Replacemnt of T1965 with T2878

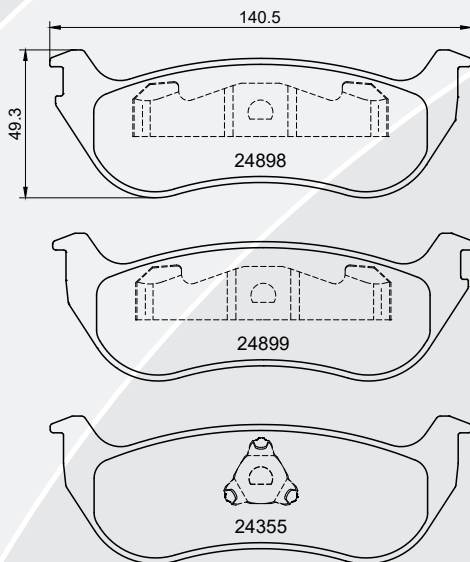
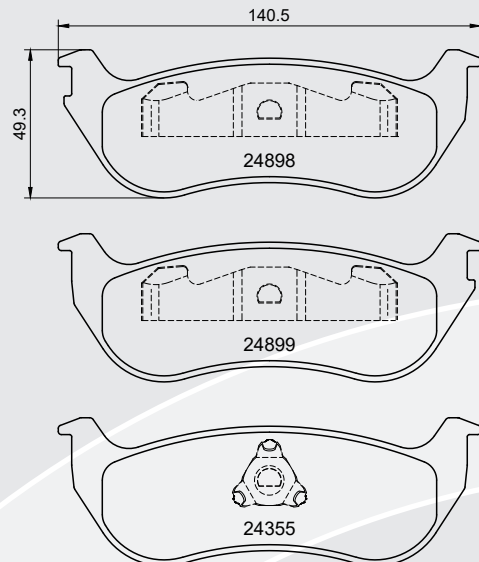
Pagid is now able to harmonize the references T1965 and T2878. It was proven that T2878 can also cover the applications of T1965. Therefore Pagid will replace T1965 with T2878.

Pagid decided to reduce the thickness of T2878 to 14,0 mm, which makes the two references equal and therefore Pagid decided to harmonise T1965 with T2878. There will be no difficulties during installation and operation.

As usual, existing stock of T1965 can be sold out without any problems.
